# HORIZONTAL DISPLACEMENT, JUST PRIOR TO SLIDING, AT CASK/PAD INTERFACE

NUCLEAR REGULATORY COMMISSION

Docket No. \_\_\_\_\_ Official Ex. No. 92

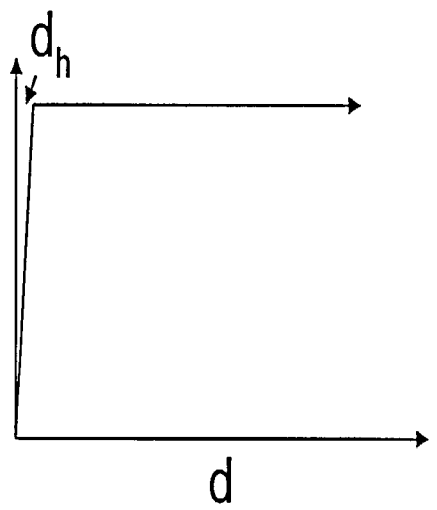
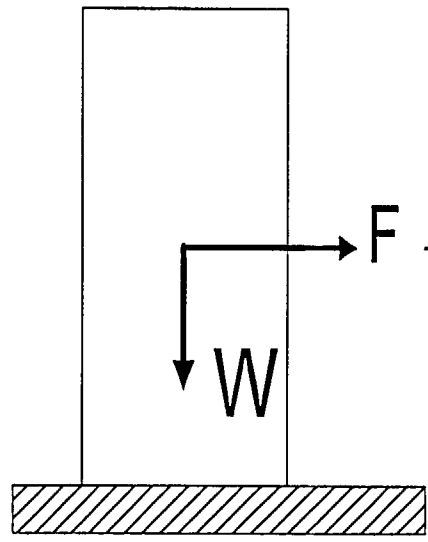
◆ Horizontal distance,  $d_h$ , just prior to sliding, is unrealistic!
